ATTACHMENT A

Revise the Technical Specification pages as follows:

## Attachment B

## Detail Description of Changes

Figure 3.1-1: Ginna Reactor Vessel Heatup Limitations Applicable for the first 21 EFPY using Reg Guide 1.99, Rev. 2

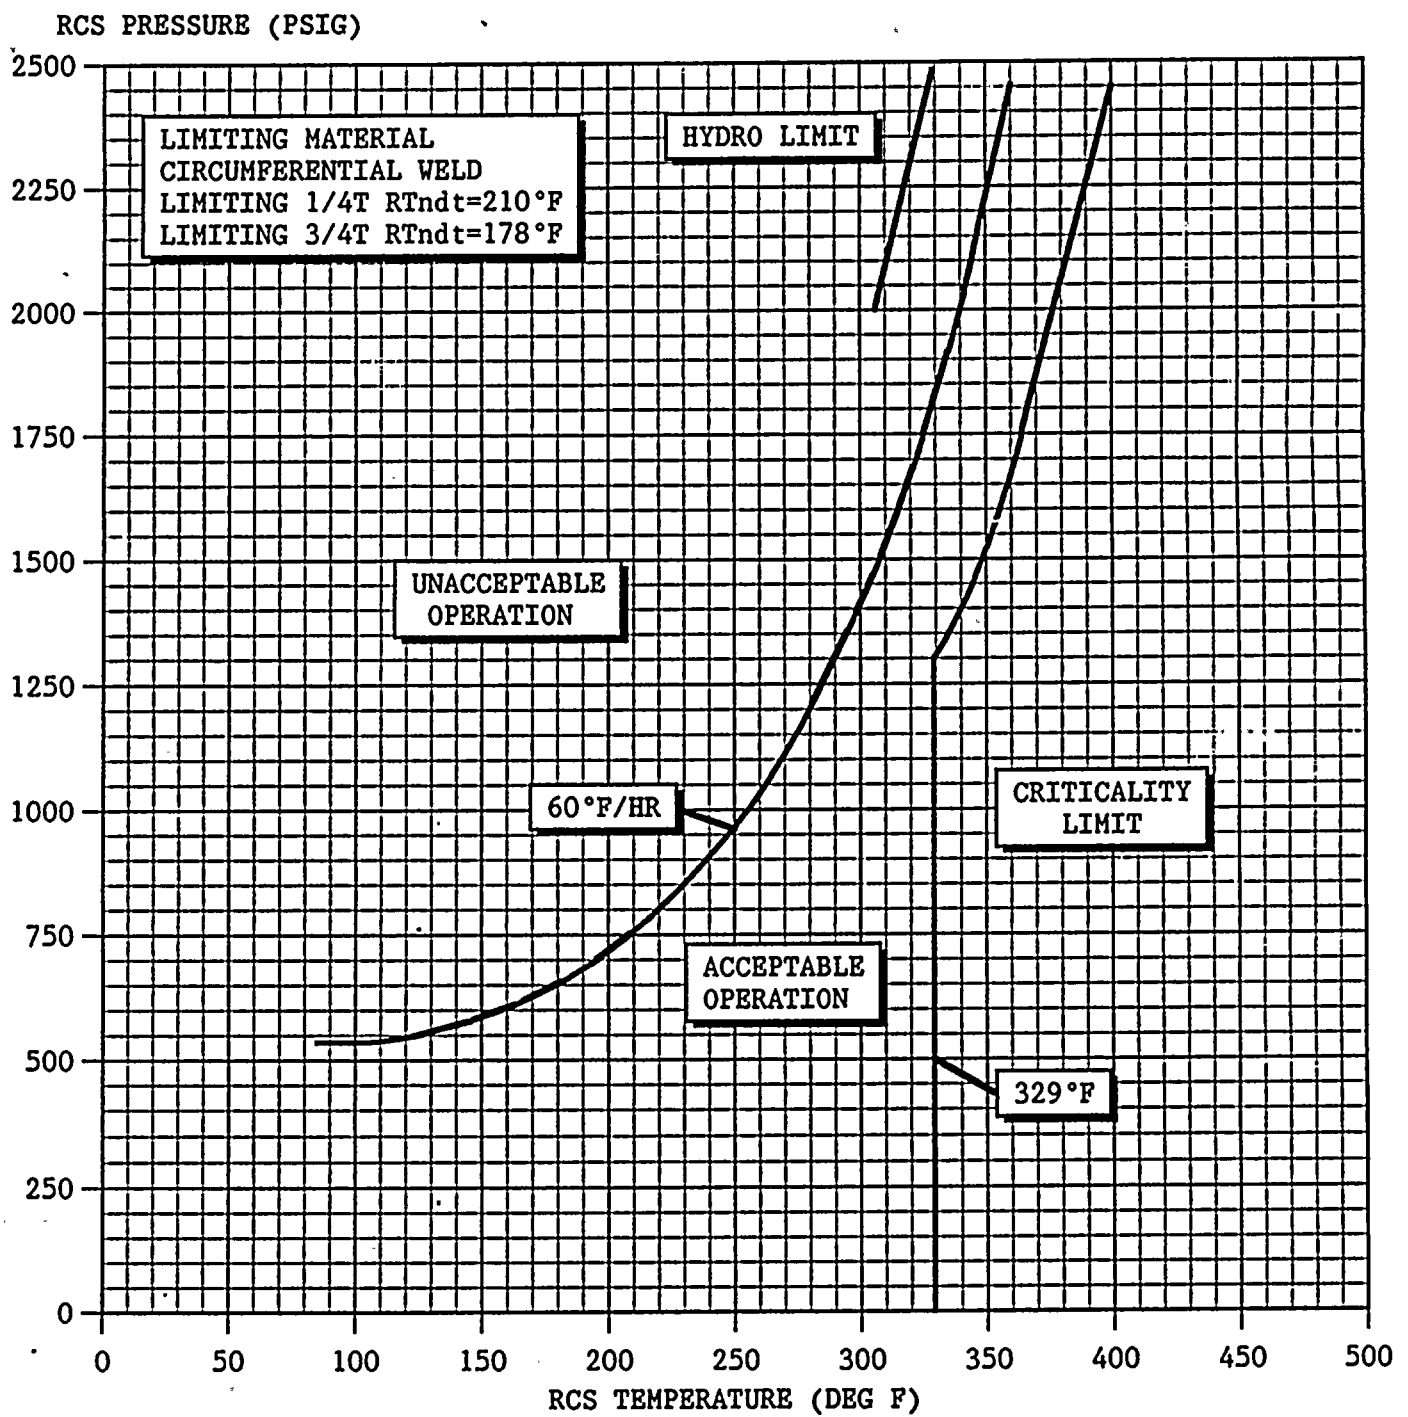
The reactor coolant temperature and pressure and system heatup and cooldown rates (with the exception of the pressurizer) shall be limited in accordance with Figures 3.1-1 and 3.1-2 for the first 21.0 effective full power years.

- a. Allowable combinations of pressure and temperature for specific temperature change rates are below and to the right of the limit lines shown. The heatup and cooldown rates shall not exceed 60°F/hr and 100°/hr, respectively. Limit lines for cooldown rates between those presented may be obtained by interpolation.

- b. Figures 3.1-1 and 3.1-2 define limits to assure prevention of non-ductile failure only. The limit lines shown in Figures 3.1-1 and 3.1-2 shall be recalculated periodically using methods discussed in the Basis Section.

- c. If the limits on Figures 3.1-1 and 3.1-2 are exceeded, restore the temperature and/or pressure to within the limit within 30 minutes; and either
  - 1) within 6 hours, perform an engineering evaluation to determine the effects of the out-of-limit condition on the structural integrity of the Reactor Coolant System and determine that the Reactor Coolant System remains acceptable for continued operation, or

Generic Letter 88-11 (Ref. 1) transmitted a copy of Revision 2 to Regulatory Guide 1.99. GL 88-11 required each Licensee to re-evaluate the effect of neutron radiation on reactor vessel material using the methods in Revision 2. If the re-evaluation resulted in more restrictive heatup/cooldown curves the new curves should be used to revise Technical Specifications. The re-evaluation resulted in new curves for R. E. Ginna. The new curves are presented on Figures 3.1-1 and 3.1-2 in Attachment A.

The curves on Figure 3.1-1 and 3.1-2 were generated using the methodology presented in Revision 2 to Reg. Guide 1.99. The curves are applicable for 21.0 EFPY. Currently Ginna has accumulated approximately 15.4 EFPY. The curves are based on nominal values, i.e. the pressure and temperature instrumentation uncertainties are not included. This is consistent with standard practice. The requisite conservatism has been sufficiently addressed by the algorithm from which Appendix G limits are derived.

- 1) Revised heatup/cooldown curves based on Rev. 2 to Reg. Guide 1.99 methodology.

Page 3.1-17	<p>Page 3.1-17 changed to 3.1-13</p> <p>Figure 3.1-1 changed to new heatup curve</p>	New heatup curve
Page 3.1-18	<p>Page 3.1-18 changed to 3.1-14</p> <p>Figure 3.1-2 changed to new cooldown curve</p>	New cooldown curve
